Access Compliance Report

Public Rights-of-Way

Intersection ID: 15133	Main Street: PERIMETER_POINTE_PY	Cross Street: W_TYVOLA_RD	Location: SE
ADA ID: 365F7BBEBAC0	Ramp Type: Para	Initial Pass/Fail: Pass	Overall Compliance: No
Severity Score: 5			
Codes/Mitigation Info/Possible Solution		Field Measurements/Component Compliance

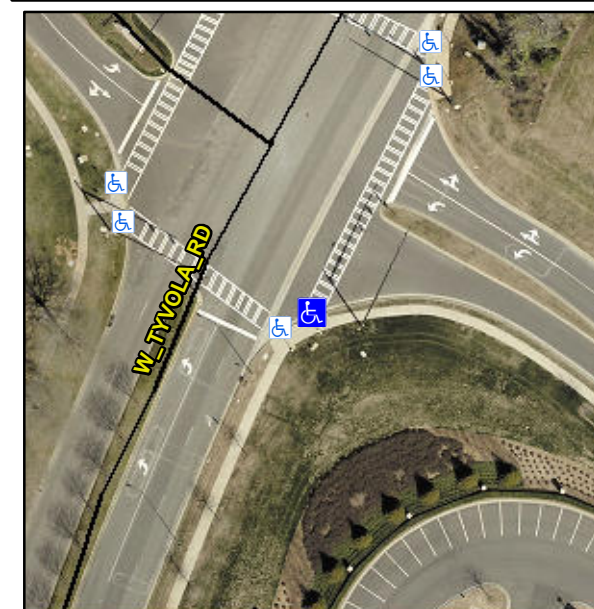
**Not Found, R304.2.1, R305.2,
R304.5.4**

Compliance	Description	Data	Compliance	Description	Data
N/A	Ramp Length LT (in)	72.0	N/A	Ramp Length RT (in)	72.0
Yes	Ramp Width LT (in)	69.5	Yes	Ramp Width RT (in)	70.5
Yes	Ramp Slope LT (%)	6.8	Yes	Ramp Slope RT (%)	5.8
Yes	Ramp XSlope LT (%)	0.8	Yes	Ramp XSlope RT (%)	1.7
Yes	Landing Length (in)	98.0	Yes	DWS Provided?	Yes
No	Landing Width (in)	47.5	Yes	DWS Contrast?	Yes
Yes	Landing Slope (%)	1.0	Yes	DWS Length (in)	24.0
Yes	Landing X Slope (%)	1.2	Yes	DWS Full Width?	Yes
N/A	Landing Curb? (Y/N)	No	No	DWS Offset (in)	5.0
N/A	Shared Landing?	No			
Yes	Gutter Ponding?	No	No	Gutter Slope (%)	6.7
Yes	Gutter Lip Ht (in)	0.0	Yes	Gutter X Slope (%)	1.9
N/A	Painted X Walk1?	Yes	N/A	Painted X Walk2?	N/A
	X Walk 1 Direction	To NE		X Walk 2 Direction	N/A
N/A	X Walk 1 Width (in)	99.0	N/A	X Walk 2 Width (in)	N/A
	X Walk 1 Slope (%)	0.8		X Walk 2 Slope (%)	N/A
	X Walk 1 X Slope (%)	1.6		X Walk 2 X Slope (%)	N/A
Yes	Ramp inside XWalk1?	Yes	N/A	Ramp inside XWalk2?	N/A

Road Slope (%)	N/A	N/A	Clear Space?	Yes
	Road X Slope (%)	N/A	N/A	Clear Space to XWalk (in)	N/A
Yes	Any Obstructions?	No	Yes	Storm Grate/Utility Hazard?	No
	Obstruction Type			Storm Grate/Utility Type	
		N/A			N/A
			Yes	Surface Condition? (G/P)	Good
			Replace	Curb Slope (%)	9.6

**Remove & Replace Entire Ramp.
Remove & Replace Gutter.**
